SUBDIVISION REVIEW SHEET

CASE NO.: C8-2021-0078.1A

SUBDIVISION NAME: Cearley Community Subdivision

CITY OF AUSTIN –DEVELOPMENT SERVICES DEPARTMENT SUBDIVISION APPLICATION – MASTER COMMENT REPORT

SHEET
1
OF 3

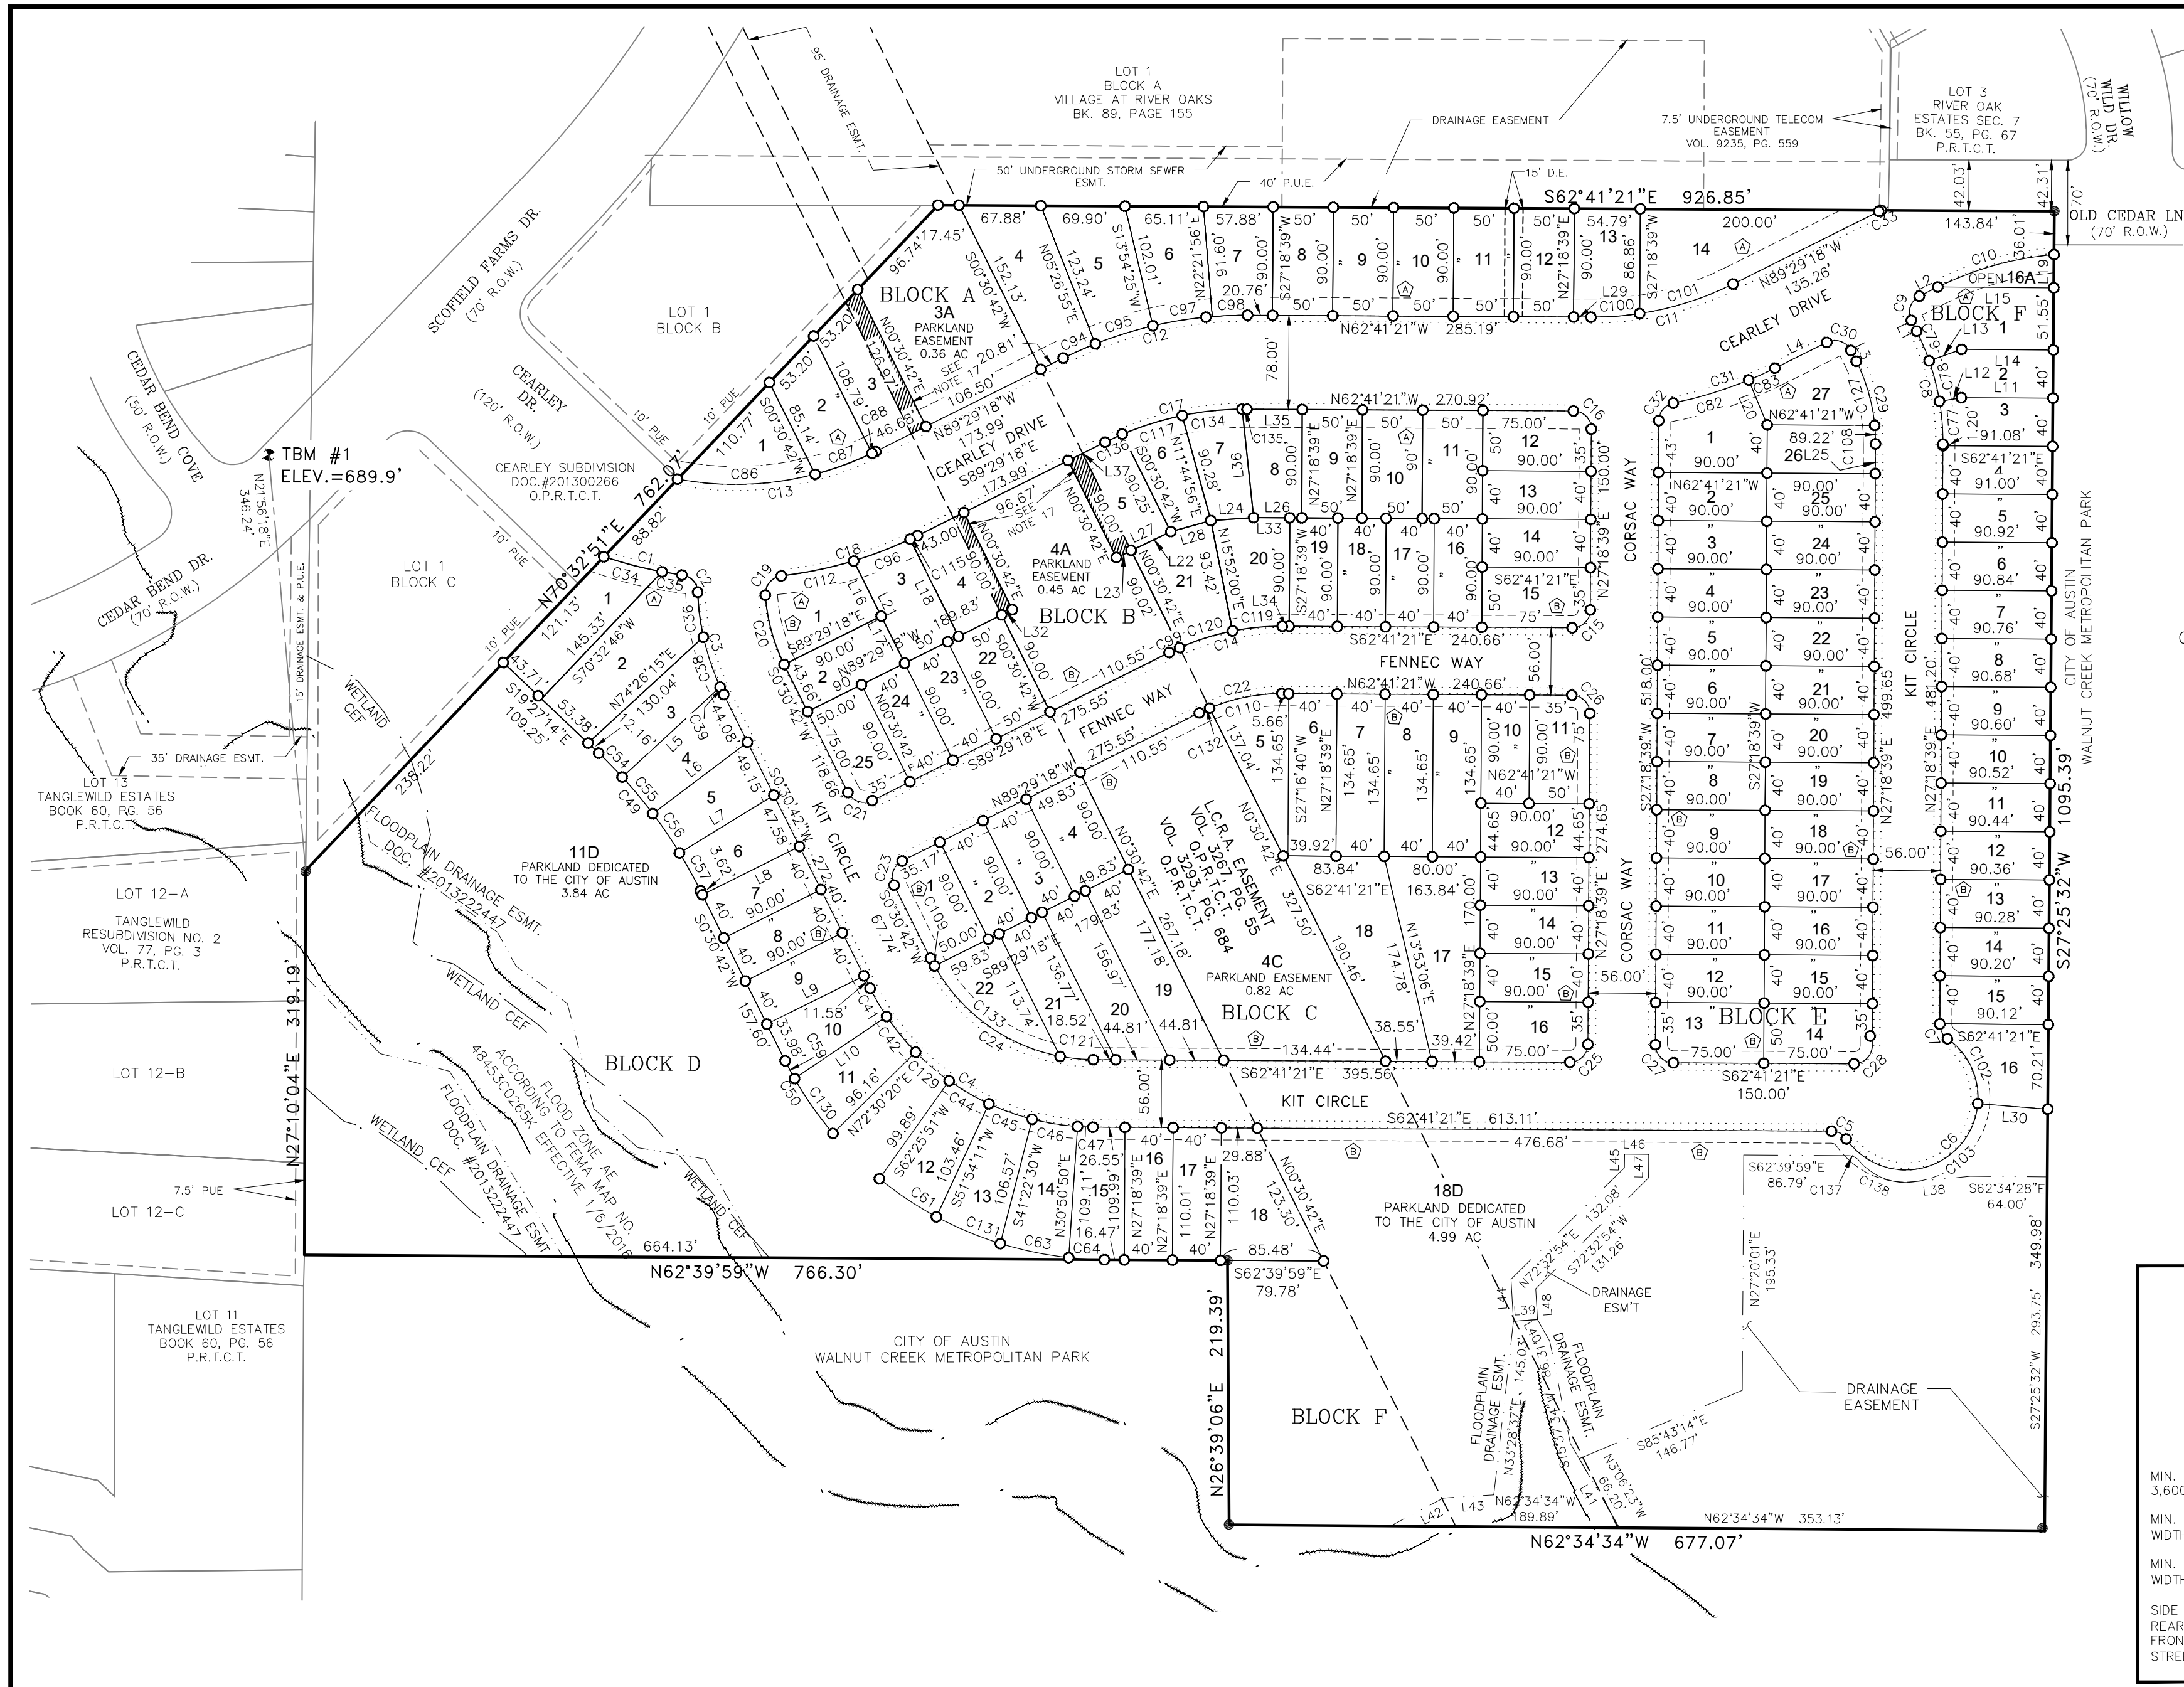
U2: Calculations complete. Please update parkland acreages on plat page to match color parkland exhibit. Fiscal memo has been written and will be sent to the applicant so that fiscal can be posted prior to subdivision approval. Comment pending posting of fiscal.

U2: Please update note #18 to indicate total amount of parkland by deed and easement. My calculation is 4.83 acres.

EL 2. U2: **Comment stands.** According to 1.2.2 Exchange of 128kV Transmission Circuits of the 1997 Transmission and Communications Agreement, Austin Energy owns the west half of the transmission easement that contains AE transmission structures and circuits. Please remove parkland easements from the western half of the easement.
